Campaign No. 2014070002, August 2014

SUBJECT: **Model 204.9, Model Year 2014**  
**Rework PVC Seam of A-pillar to Rocker Panel**

Figure 1

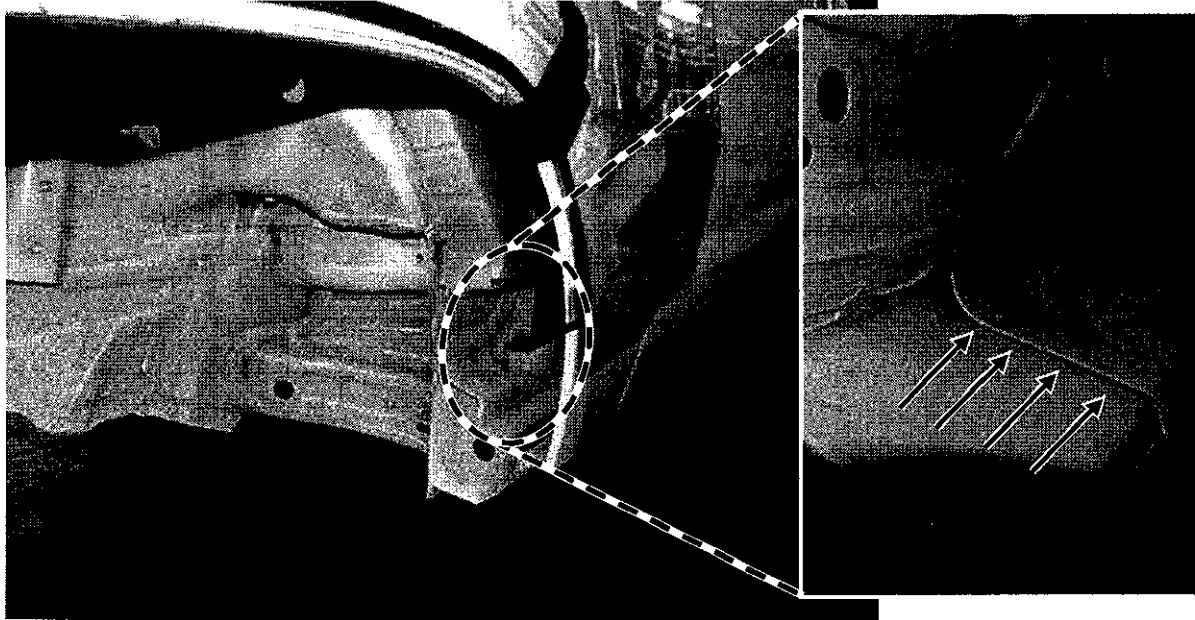
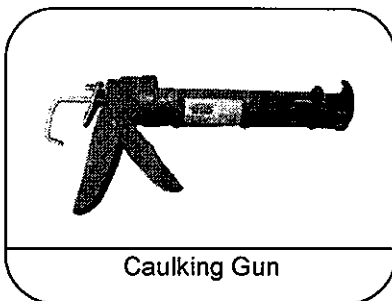
This Service Campaign has been initiated because Daimler AG (DAG), the manufacturer of Mercedes-Benz vehicles, has determined that a seam seal at the left A-pillar does not correspond to current production configuration. As a consequence, it is possible that water leaks may occur in this area. An authorized dealer will rework the seam seal at the left A-pillar at the next workshop visit.

1.  Remove left front wheel.
2.  Detach wheel arch liner on lower left front.
3. Seal exposed edge of A-pillar connection to rocker panel (arrows, Figure 1).

Be sure to clean affected area prior to applying seam sealant.

Use a standard size caulking gun to apply the seam sealer p/n A 004 989 29 20 which is a 310ml caulking tube with the standard size plastic applicator tip.
